**ADDENDUM # 1**  
Parker Gray Field

March 06, 2019

**ACPS T.C. WILLIAMS H.S. - PARKER-GRAY STADIUM RENOVATION**

**5**  
E0.02  
**TYPICAL FIELD LIGHTING POLE DETAIL**  
SCALE: NONE

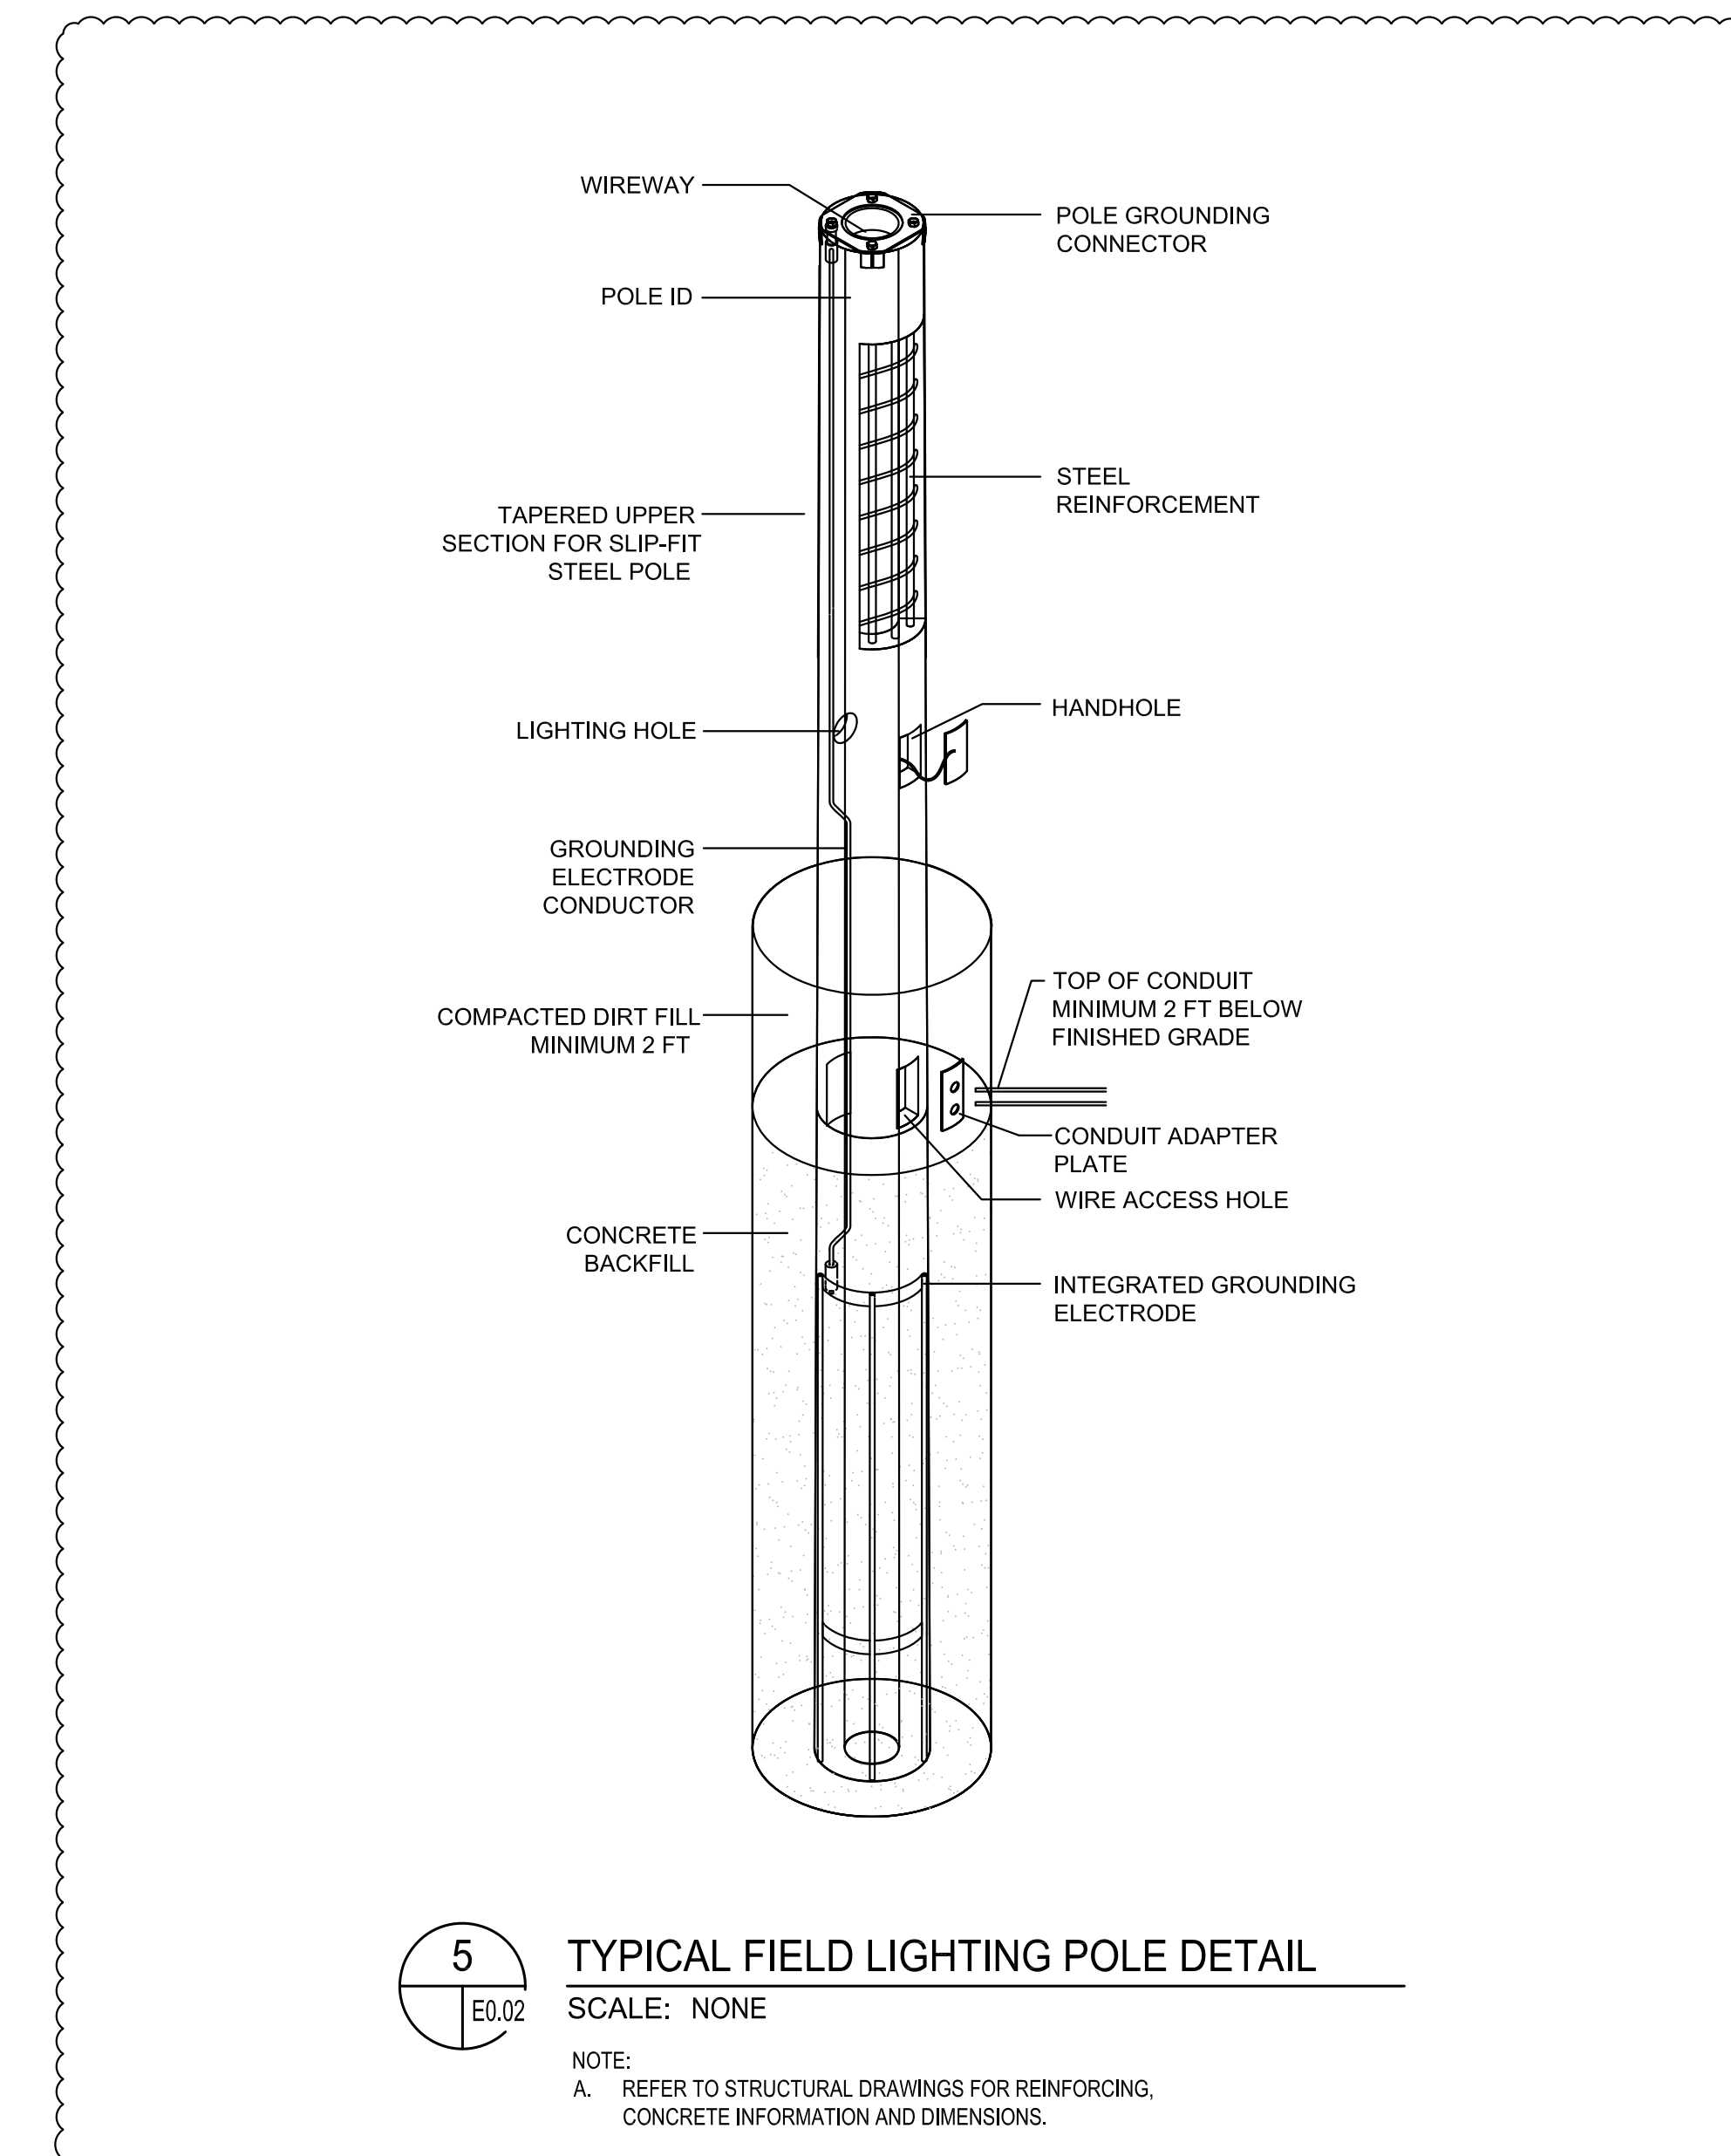
- Normal and emergency conduits from Elec/Mech room 105B in storage building to field lighting poles
- Pole foundations and conduit rough ins per detail 5 on E0.02
- Circuit breakers for athletic lighting contactors and emergency lighting inverter in panel DPH
- Pedestrian lighting poles and fixtures (ST1,ST2) per schedule on E0.01
